**LEMOORE PLANNING COMMISSION**  
**Special Meeting**  
**AGENDA**  
**Lemoore Council Chamber**  
**429 'C' Street**

**To:** Lemoore Planning Commission **Item No. 8**  
**From:** Steve Brandt, City Planner  
**Date:** January 17, 2023 **Meeting Date:** January 23, 2023  
**Subject:** **Amendment to Major Site Plan Review No. 2020-01:** A request by Lennar Homes to remove master home plan 7511 and modify elevations of the Clementine Master Home Plan Series 7512, 7514, 7515 for Subdivision Tract 848, an approved 362-lot single-family residential subdivision to be developed in three phases with a 1.06-acre park on 54.1 acres. The project is located south of Bush Street and east of College Avenue, in the City of Lemoore (APNs: 023-510-040 and 023-480-031, 023-660-001 through 075, and 023-680-001 through 055, and 023-670-011 through 064).

Modification to  
Major Site Plan  
Review

Approved Master Plan Options the Plum Plan 7511

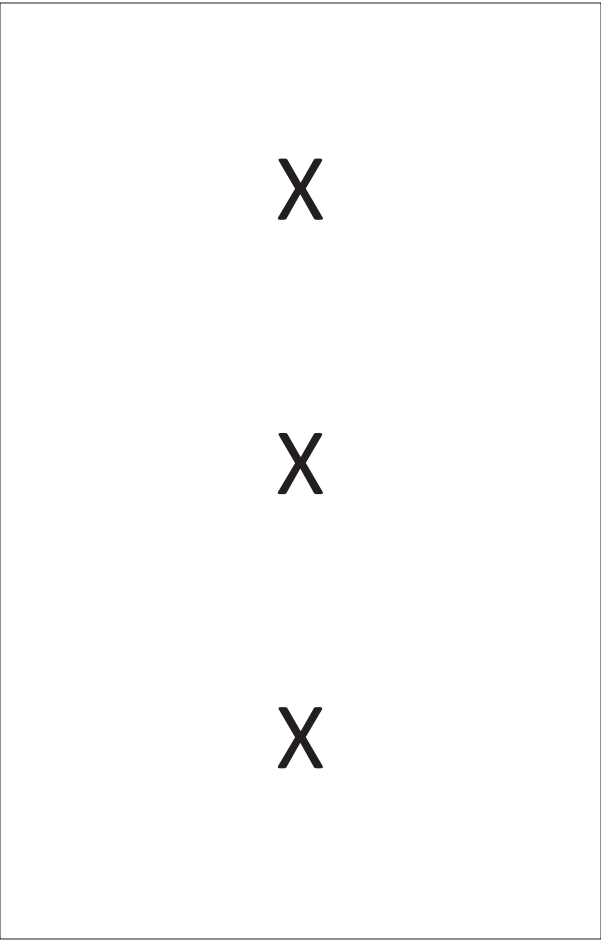
Plan 7511: Plan no longer offered.

To be Removed from Master Home Plan Options

PROPOSED ELEVATIONS (RENDERINGS)

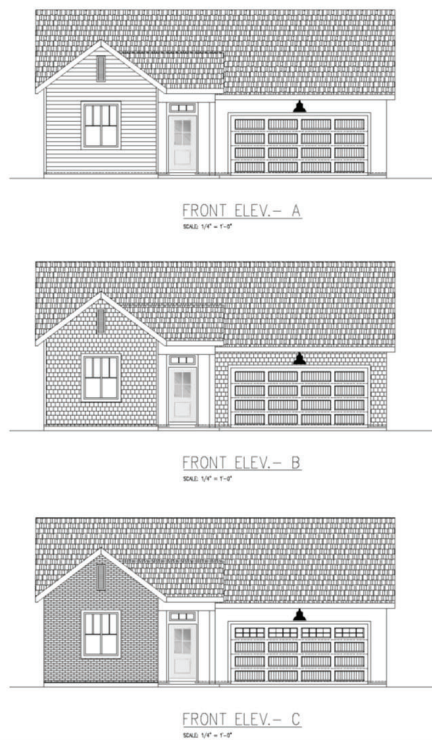
7515 A- Replace scabbed on roof above garage with decorative stucco band. Change garage door to 4 panel door. Replace siding on front facing gable with stucco. Add carriage lights to either side of the garage. Change entry post from stucco to stone. Upgrade front door to larger glass panel. Variation in roof color added to color schemes.

7515 B- Replace scabbed on roof above garage with decorative stucco band. Change garage door to 4 panel door. Change shingle cladding on garage portion of the house to stucco. Add carriage lights to either side of the garage. Change entry post from stucco to stone. Upgrade front door to larger glass panel. Variation in roof color added to color schemes.

7515 C- Replace scabbed on roof above garage with decorative stucco band. Change garage door to 4 panel door. Add carriage lights to either side of the garage. Change garage door to 4 panel door with windows. Change entry post from stucco to stone. Upgrade front door to larger glass panel. Variation in roof color added to color schemes.

LENNAR 8800 N. PALM AVE. SUITE 110 PLEASANTON, CA 94566 (925) 766-1000 WWW.LENNAR.COM	
PROJECT LEVOCORE PLAN 7315 (PERSIMMON)	SHEET A-3

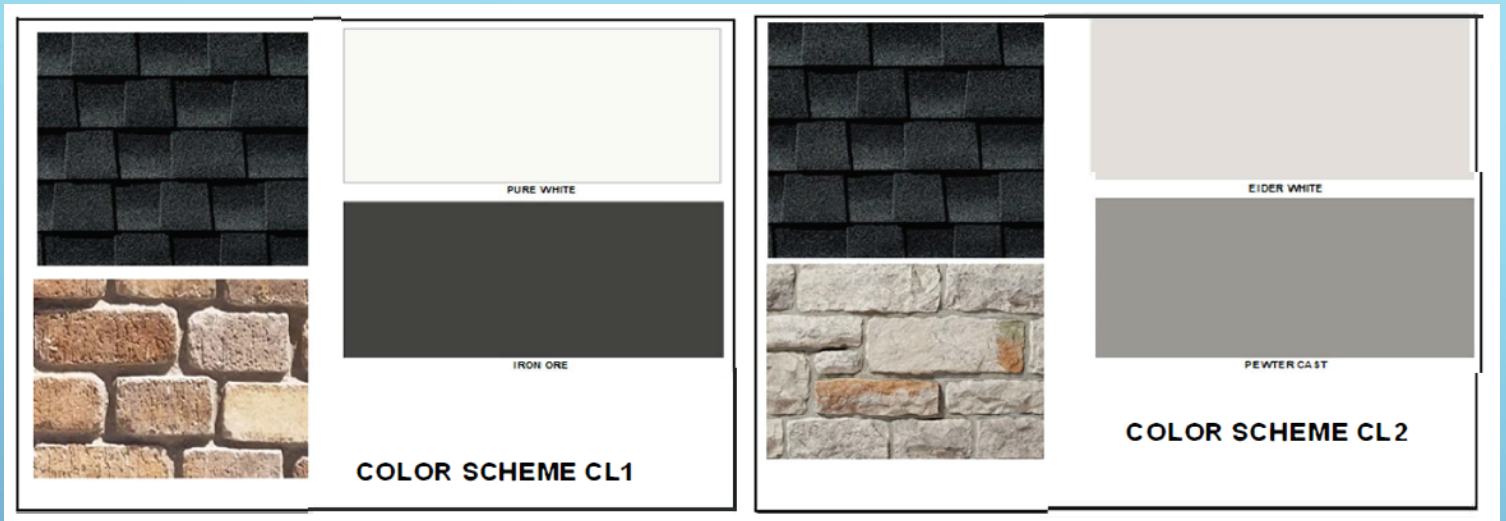
Plan 7515 A & B:

- Replace scabbed on roof above garage with decorative stucco band.
- Change entry post from stucco to stone.
- Add two carriage lights to either side of garage.
- Change decorative garage door with windows to 4 panel door with windows.
- Upgrade front door with larger glass panel.
- 2 roof color options (currently only one available for 10 home color scheme options).
